Suunnitteluvaltion lentokelpoisuusmääräys (Yhdysvallat) AD98-15-18R1**Maule Aerospace Technology. Siipitukien tarkastus.**

Appendix to AD 98-15-18 R1**Procedures and Requirements for Ultrasonic Inspection of Maule Wing Lift Struts****Equipment Requirements**

Figure 1

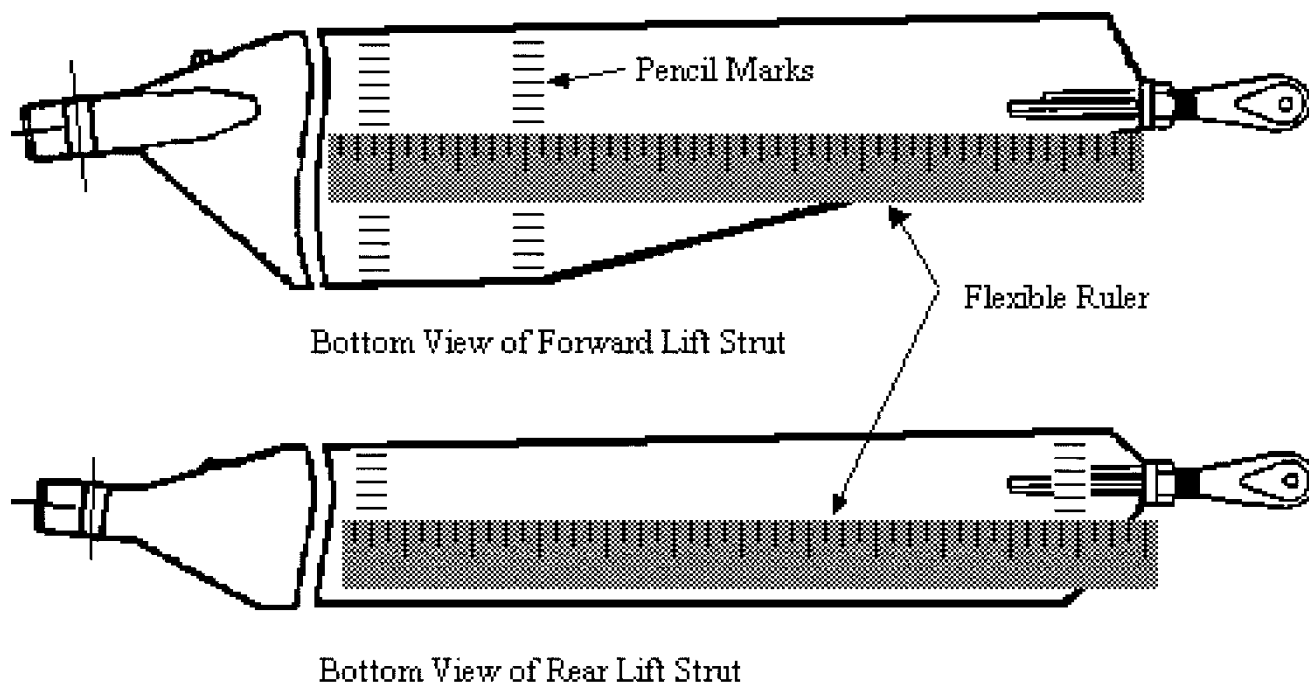
2. Using a flexible ruler, draw a 1/4-inch grid on the surface of the first 11 inches from the lower end of the strut as shown in Maule Air, Inc. Service Bulletin No. 11, dated October 30, 1995, as applicable. This can be done using a soft (2) pencil and should be done on both faces of the strut. As an alternative to drawing a complete grid, make two rows of marks spaced every 1/4 inch across the width of the strut. One row of marks should be about 11 inches from the lower end of the strut, and the second row should be several inches away where the strut starts to narrow. Lay the flexible ruler between respective tick marks of the two rows and use tape or a rubber band to keep the ruler in place. See Figure 1.
